PZ&B Staff Combination Memorandum: Landmarks Preservation Commission and Town Council

SUBJECT: COA-24-0018 (ZON-24-0043) 100, 101, 102, and 103 FOUR ARTS
PLZ—SOCIETY OF THE FOUR ARTS

MEETING: January 22, 2025, TC
February 12, 2025, LPC

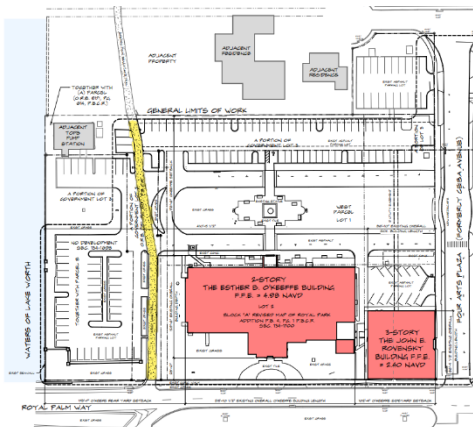
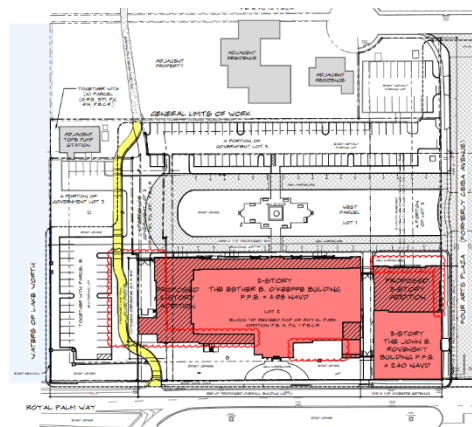
As previously mentioned, the existing Lake Trail right-of-way traverses the west campus towards the western side of the site. To accommodate the proposed additions to the O’Keeffe building, the application seeks to abandon this easement to reconfigure the pedestrian path slightly to the west. The formal abandonment and new dedication will be processed separately, however, is it recommended that it be discussed during the site plan review since it impacts the proposed configuration of the site (and possibly additional parking space loss). A general consensus for the direction of the application as it pertains to the relocation of the Lake Trail would be appropriate.

South Elevation – Summary of Revisions:

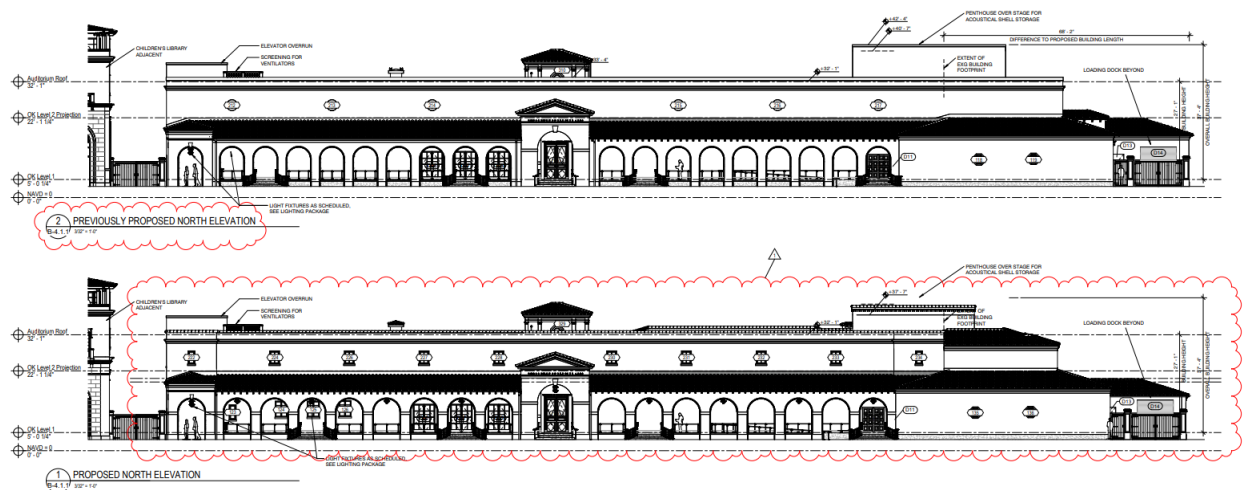
With the previous design, there were concerns that the proposed alterations and additions to the O’Keeffe Building could negatively affect the architectural and historic character of the building. The previous design enveloped the north, west and south facades of the O’Keeffe Building, significantly impacting the Addison Mizner designed structure. The previous proposal was particularly impactful to the south façade which fronts Royal Palm Way. A visible gateway to the Town that will, as proposed, have more structure and less greenspace adjacent to Royal Palm Way.

While there have been additions and alterations over the years, the essence of Mizner’s design has remained, especially on the south façade. The additions and alterations by other prominent Palm Beach architects, John Volk in 1947 and Wyeth, King and Johnson in 1957, respected the importance of Mizner’s design for the south façade and did not significantly alter its design or massing. Additions were set back from the main façade or located on other facades. From a historic preservation perspective, additions to the O’Keeffe Building should be designed to not obstruct the Mizner design, should read as additions, and complement the original design while not overwhelming it. If additional space is needed, the west façade would be the best one to explore for such opportunities since little to no architectural details exist on that façade. The north elevation modifications are more restrained. Since the north elevation was long considered more of a rear façade from a hierarchy standpoint, it is a more acceptable place for additions.

At the November 12, 2024, LPC meeting, the project was deferred to the January 22, 2025, meeting to re-study the north arcade’s articulation, examine elements deemed too tall, such as the fly tower and the west addition’s roofline, and to eliminate the southeast corner addition.

- Window trim color lightened to off-white pending paint analysis, with verdigris accent color for doors and specialty windows.
- Southeast addition (1,026 GSF) now removed from proposal, Mizner’s southeast windows in this location to be rebuilt according to original drawings.

- Revised to cascade the eave lines of the one-story roofs of the southwest additions down progressively moving westward.
- Second-story parapet replaced with tile roof; chimney, four windows, and an 11-bay open-air loggia integrated. Three windows are now also provided on the second-floor southeast corner (matching the original location in elevation).

- The 11-bay open-air loggia is integrated into the south façade design, centered over octagonal windows, using the reference of Mizner’s open-air loggias for the Embassy Club for the piers and brackets. The roof over this zone has its own massing, elevated with offset eaves and a hipped roof to read separately from the western expansion. Ornamental (nonfunctioning doors) were added to the back wall of the loggia.

- The 1st-floor plane break offset doubled to 2 feet (from 1 foot).
- The extent of westward expansion was reduced by 3 feet.
- Acoustical Penthouse: Height is reduced by 2 feet, and width is reduced by 7 feet.

- Acoustical Penthouse: Crenelated corbeling and barrel tile cap detail added to provide traditional scale and color.
- Groupings of windows to the west are tied together with common sills and centered over octagonal windows below.

- The additions do not touch Mizner’s tower.

North and East Elevations – Summary of Revisions:

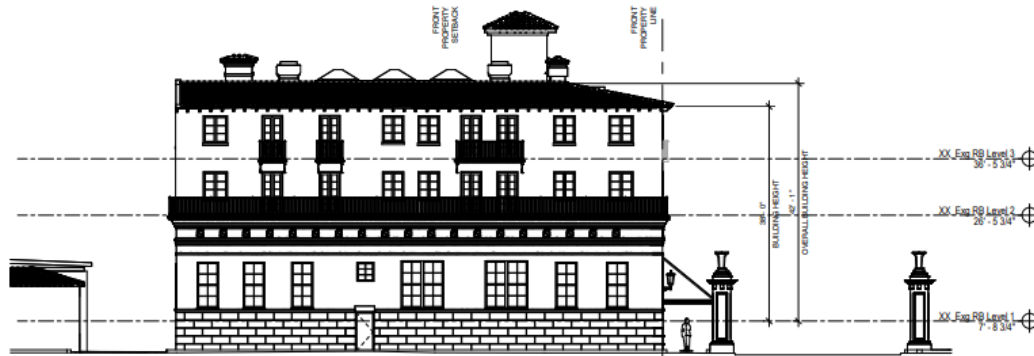
The previous design for the proposed addition to the Rovensky Building was sited in an appropriate manner, but the height and exterior details of the addition detracted from the landmarked structure. Additions to historic structures should not overwhelm original elements and massing and should read as secondary to the historic portion. As previously designed, the Rovensky Building appeared subservient to the proposed addition. This three-story addition was most visible from the east and north elevations. The connector piece could benefit from further refinement. Modifications to the Rovensky building were also proposed such as window spacing and rhythm as well as the addition of a tiled sloped roof on the west façade.

At the November 12, 2024, LPC meeting, the project was deferred to the January 22, 2025, meeting to re-study the scale of the windows and doors to ensure they are subordinate to or match the existing structure, reduce the prominence of the entrance, connection, and pavilion elements, review precedents within the Town, and scale down the third-floor boardroom.

- All openings and details have been revised/reduced in scale to reduce overall reading.
- Hyphen has been made much quieter visually, the first-floor cornice made simpler and lower. Arched windows removed from east elevation.

- The northeast pavilion windows are now smaller, more similar to King Library windows.
- The second-floor typical windows match the existing building, increased in number (for spacing more consistent with the existing building).

- The second-floor north wall moved south by 3 feet.
- The northwest tower windows were changed to grouped arched.
- The water table is now removed, arched openings removed on the east elevation and reduced on the north.

- The north arches match the height of those on the King Library.
- The entry arch is significantly smaller.
- A small door for children has been added next to the main entry/egress door.

- Ornamental grillwork will cover the entire storefront.
- The amount of stone reduced in favor of stucco; the tall water table and quoining now removed.

- The proposed board room pavilion roof ridge was lowered by 3 feet and is now to be under height of existing roof. Pavilion eaves were lowered by 18" to match the existing building.

- The pavilion metal roof and storefront below were changed from dull bronze color copper to verdigris pre-patinated copper.
- Pavilion massing broken into multiple elements, massing revised, all details revised. The entire board room massing shifted south by 5 feet and the ridge is now centered on building east elevation. Eaves converted from integrated gutter and broad standing seam fascia to

- finer soffits (12" overhang) plus half-round copper gutter.
- Small windows were removed.
- Corner window was removed.
